# COLNEY HEATH PARISH COUNCIL

Land to the Rear of 42-100 Tollgate Road & 42 Tollgate Road, Colney Heath

## Cycling Routes Assessments

PINS Ref : APP/B1930/W/23/3323099

**APPENDIX C - Route 2: Tollgate Road (A1(M) Tunnel) to Welham Green Station via Southway and Travellers Lane (NCR 12), Pooleys Lane, Parsonage Lane and Dellsome Lane (3.2 miles, 5.12 km) Gradient**

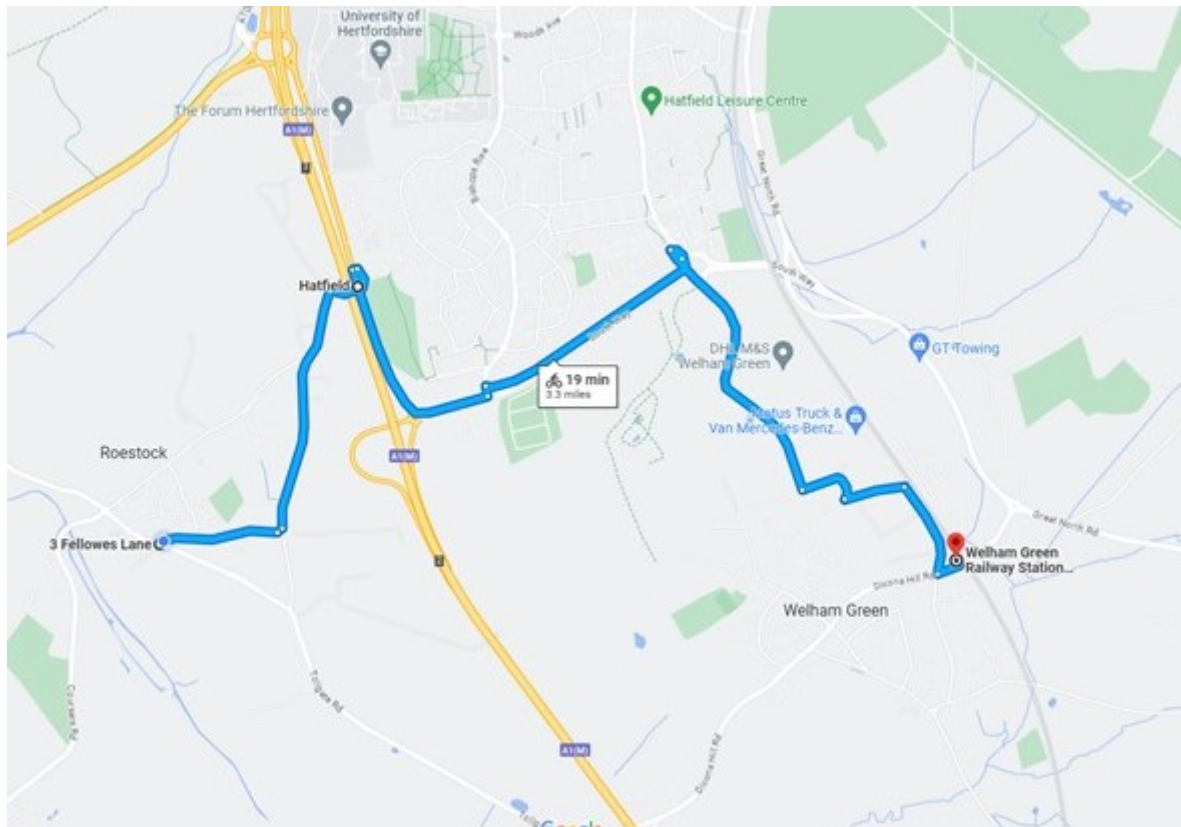
| Factor   | Ind | Comment  | Score |                 |
|--|-----|--|-------|-----------------|
| Reduce remove difference where cyclists are sharing the carriageway (at junctions) | 9   | Roehyde Way and Southway national speed limit roads (60 mph). Remainder, Pooleys La, Parsonage La and Dellsome La are 30 mph or less. The Travellers La cycle/footpath has no limit. | 0     | <b>CRITICAL</b> |
| Reduce remove difference where cyclists are sharing the carriageway (carriageway)  | 10  | Roehyde Way and Southway are wide national speed limit roads (60 mph) with fast moving traffic. Remaining roads: Pooleys La, Parsonage La and Dellsome La 30 mph or less             | 0     | <b>CRITICAL</b> |
| Risk of Collision  | 12  | Cyclists on the carriageway, not segregated, at risk of collision from behind or alongside.  | 0     | <b>CRITICAL</b> |

| <b>CRITICAL JUNCTIONS AND OTHER SIGNIFICANT HAZARDS</b> |   |
|---|---|
| A1(M) Tunnel to Southway                                | Significant gradient from tunnel to Roestock roundabout.  |
| Roestock Roundabout                                     | Three exits and three entries to roundabout including motorway slip roads. Fast traffic from all directions   |
| Travellers Lane Roundabout                              | A five-arm roundabout with fast traffic approaching on A1000. On route to Welham Green risk can be mitigated by using cycle/footpath bridge with ramp. On return normal entry into roundabout from Travellers La. |

## APPENDIX D - Route 3.0 Tollgate Road to Colney Fields, London Colney via Coursers Road

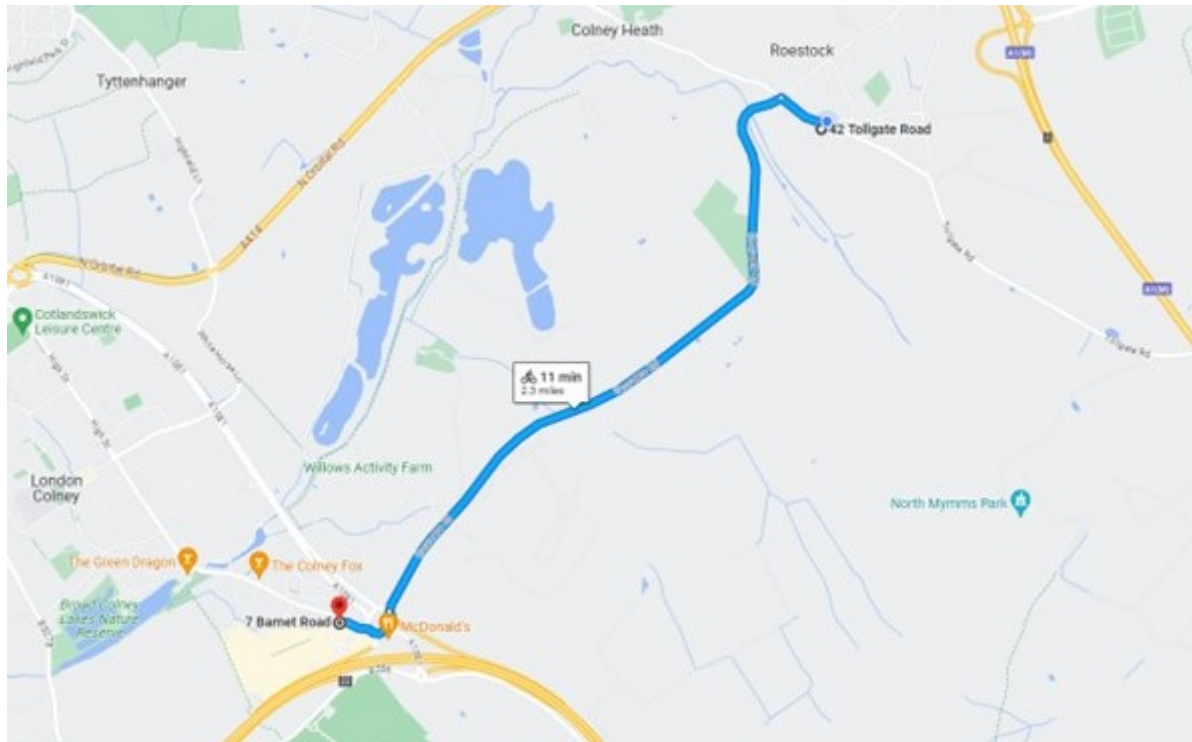
| Factor  | Ind | Comment  | Score |                 |
|---|-----|--|-------|-----------------|
| Time delay at junctions   | 6   | Delay same as for motor vehicles except for increased risk for cyclists at Bell roundabout where negotiating two traffic lanes and five entries/exits is dangerous.  | 0     |                 |
| Reduce remove difference where cyclists are sharing the carriageway | 9   | Tollgate Road: Speed of 85% traffic = 37.2 MPH (ref: TPS 5.11). Coursers Road from High Street to Mill House.<br>Speed limit on shared carriageway<br>Coursers Road to Barnet Road including Bell roundabout National Speed Limit 60 mph<br>Speed Limit Barnet Road – 30 mph | 0     | <b>CRITICAL</b> |
| Avoid High Volume Traffic   | 11  | Bell roundabout where risk of collisions is greatest has very high volumes of traffic.   | 0     | <b>CRITICAL</b> |
| Risk of Collision   | 12  | High speed differential between cyclists and vehicles<br>No segregation<br>No cycle lane on shared carriageway<br>High risk of collisions from behind or alongside.<br>No cycle preference at junctions  | 0     | <b>CRITICAL</b> |
| Risk of collision   | 13  | Conflicting cycle and motor traffic not separated at Bell roundabout a major junction.<br>No separation of cyclists and mv   | 0     |                 |

#### CRITICAL JUNCTIONS AND OTHER SIGNIFICANT HAZARDS

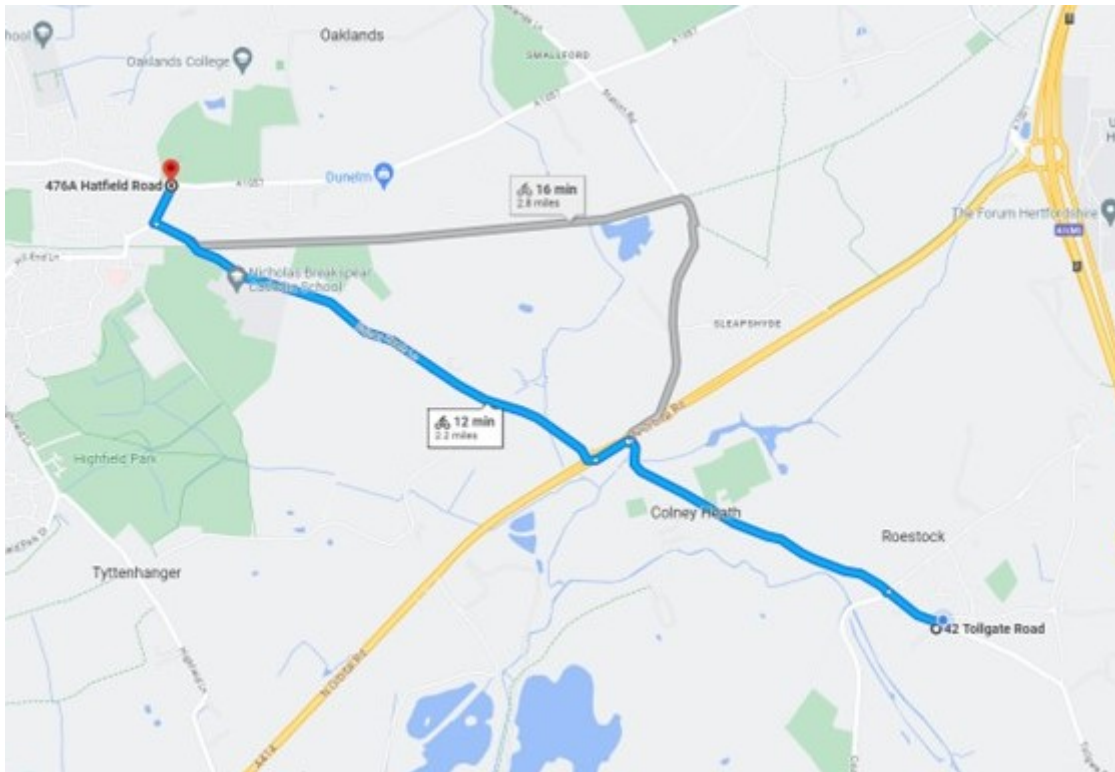
| Bell RAB | <p>Two Lane National speed limit six- arm RAB with 5 entries and six exits including a A1081 major dual carriageway, M25 on and off slip roads, a single carriageway road and a dual-carriageway Barnet Road</p> <p>Generally continuous flow of fast traffic with intermittent short breaks to allow safe access into RAB.</p> <p>Requires crossing of both high-speed entries to and exits from RAB and changing lanes.</p> |

| Landfill entrance/exit              | T junction with side road.<br>Right turning HGV across traffic lane or beside cyclists into site<br>HGV exiting site<br>Mud on road in wet weather |
| Bend in vicinity of 3 Coursers Road | Limited visibility (blind) bend<br>Partially under trees   |

#### CRITICAL JUNCTIONS AND OTHER SIGNIFICANT HAZARDS

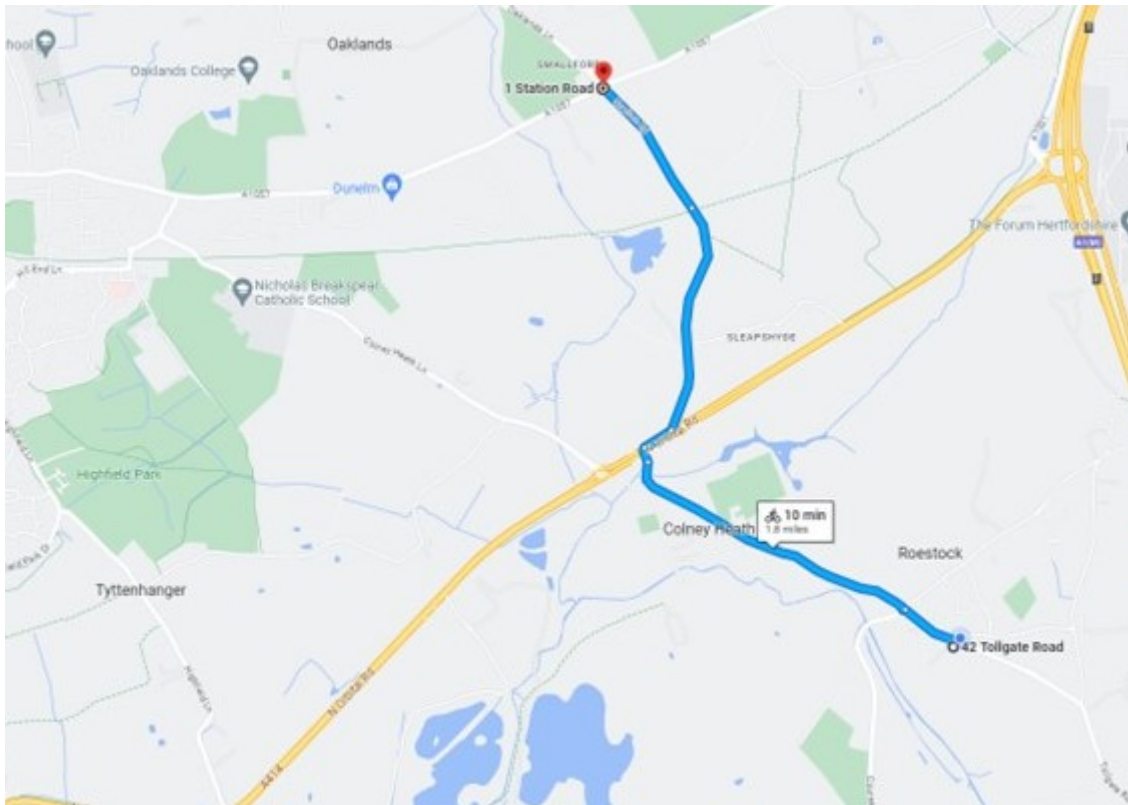
| Colney Heath Lane – 40 speed limit area | The section of 40 mph road between Barleymow Lane and the 30 limit signs narrows to such an extent that traffic slows to pass notably buses to and from school.<br>This put cyclists at risk of collision from behind or alongside. |

## APPENDIX G Route 5 Tollgate Road to Hatfield Hilltop Shops via Roestock Lane

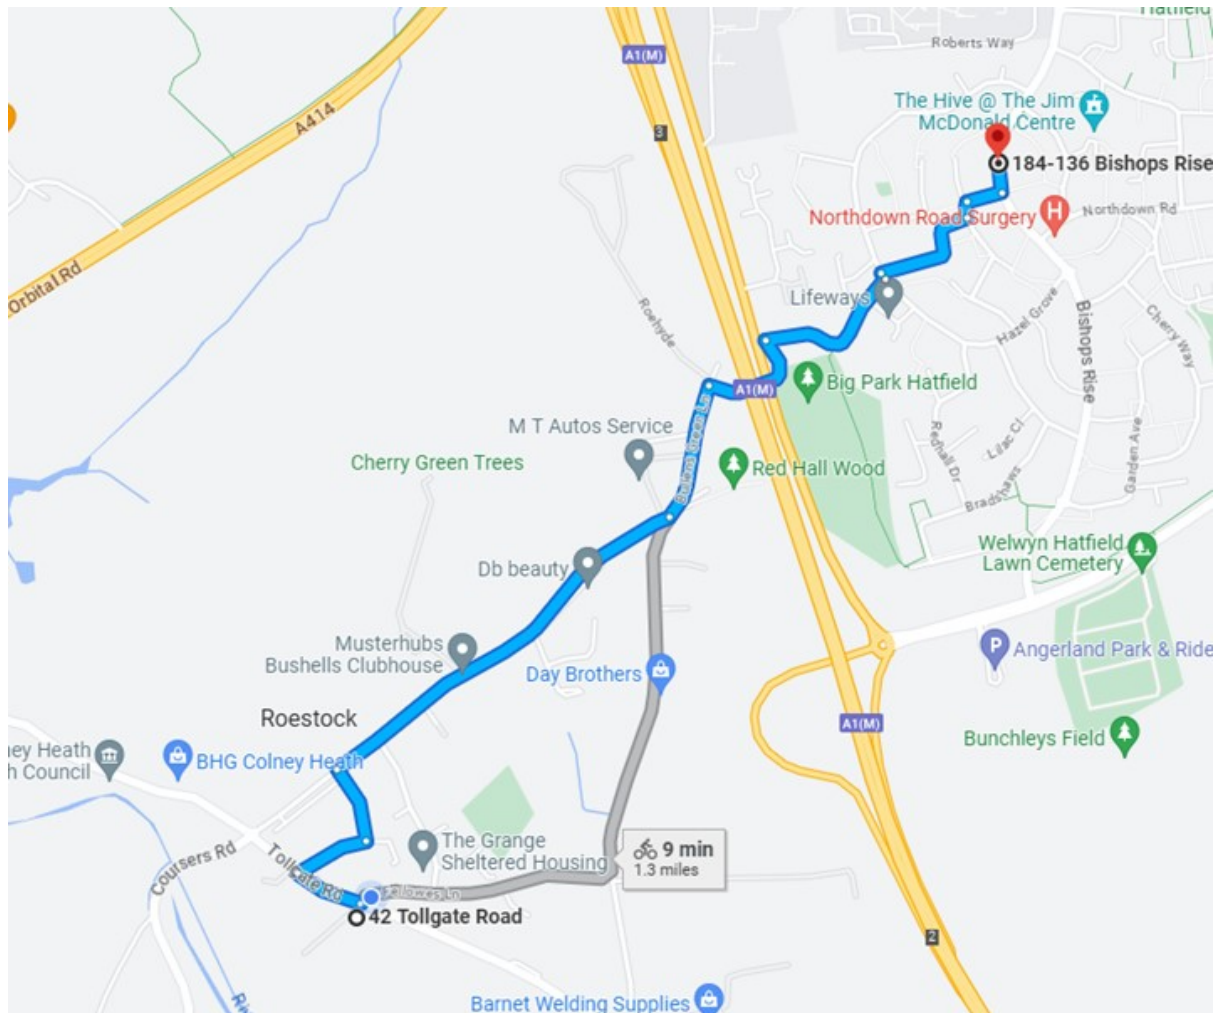
The RPS document states that there are shops and a chemist located at Hatfield Hilltop. This statement presumably indicates that these are easily accessible for both cyclist and pedestrian. To reach them is along Roestock Lane under the underpass and up Lane End, (where our Parish Councillor was violently mugged). From the underpass exit to Hilltop shops is a distance of 600m. The rise in elevation is from 71m at the tunnel exit rising to 110m at the shops. This is a gradient of 4.83%. It is no wonder that there is a 'no cycling' sign at the entrance to Lane End. .

There is no point in adding any more detail to condemn this route as unviable

### Route 6 Tollgate Road to Hatfield Town Centre via Roestock Lane

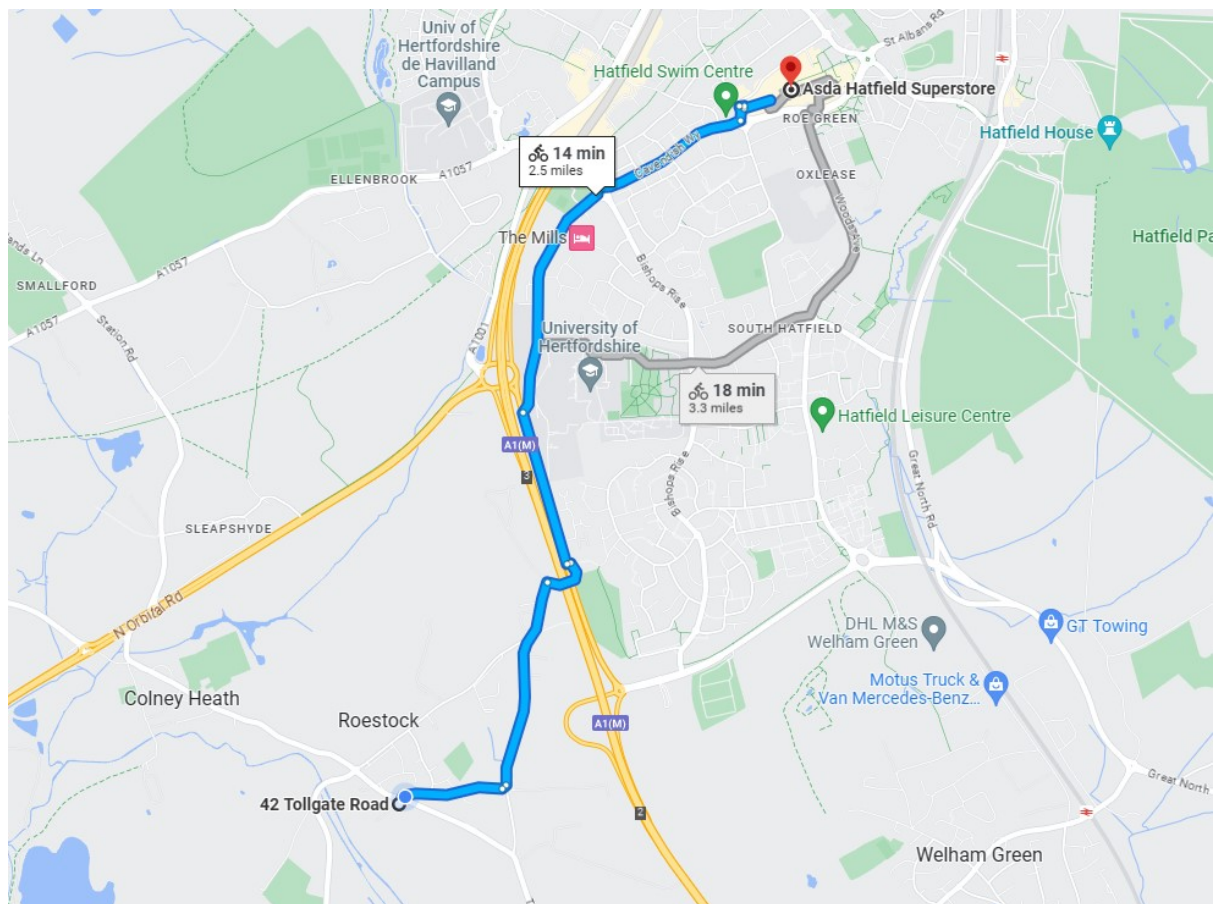
| Reduce remove difference where cyclists are sharing the carriageway | 9  | Tollgate Road: Speed of 85% traffic = 37.2 MPH (ref: TPS 5.11).<br>Roestock Lane 30MPH (no actual speed known)  | 0   | <b>CRITICAL</b> |

| Consider and reduce risk from kerbside | 15 | Parked 'chicanes of cars' provide kerbside risks. Turning onto the bottom of Roestock Lane from the roundabout the cyclist is immediately met with the situation at the Service Road junction. See also Meadway and Roestock Lane chicane photos. (see photo)<br>Roestock Lane suffers from poorly defined and overgrown verge reducing the road to one and a half lanes near the Chalkdrawers Arms.<br>Pedestrian exit from a gate at the University building causes people to step directly onto the funnelled cycleway at the bus gate in College Lane. (see photo) | 0 | <b>CRITICAL</b> |
